TO: Township of West Orange Planning Board

RE: PB Application 26-01
Planning Review # 1
15 Ridgeway Ave
Block 158 Lot 28.01
Minor Subdivision with "C" Variances

DATE: May 1, 2026

Subject Site Aerial
Source: NJ GeoWeb, March 23, 2026

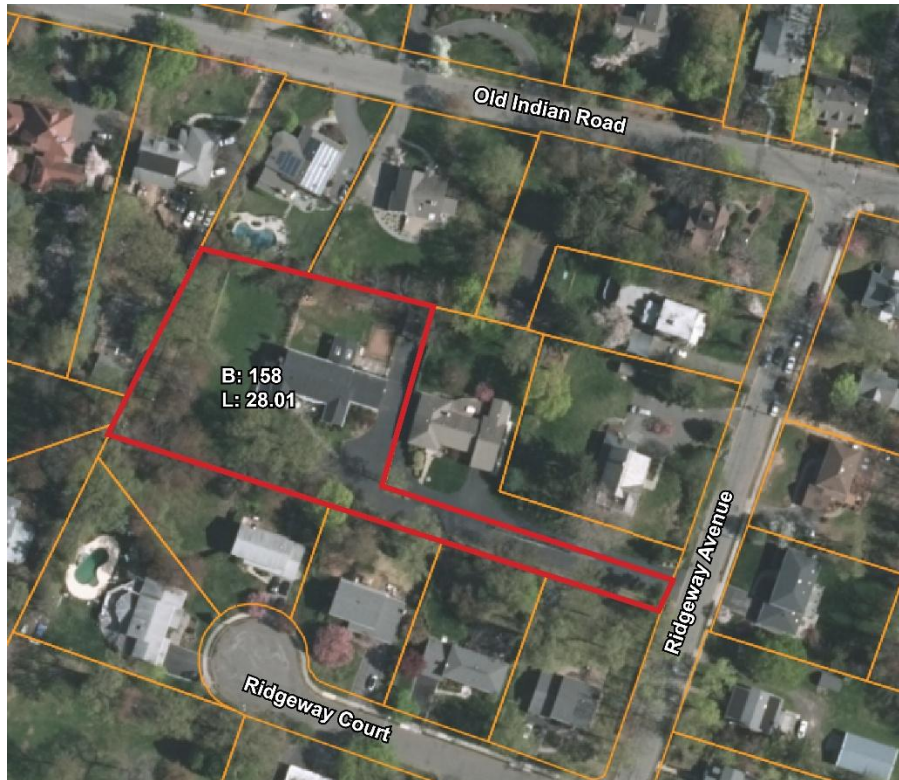
been demolished. **Applicant to confirm which structures are still existing on the property, including the fishpond, bocci court, porch, wood deck and retaining wall status.** The entire lot is enclosed with various fencing materials including a wood picket fence on the southern edge of the driveway, a wood stockade fence on the western edge, an aluminum picket fence on the northeast edges of the lot between the subject property and Lot 28.02, a vinyl stockade fence and a row of old metal fence posts in the rear yard between the subject property and lots 21.01 and 21.
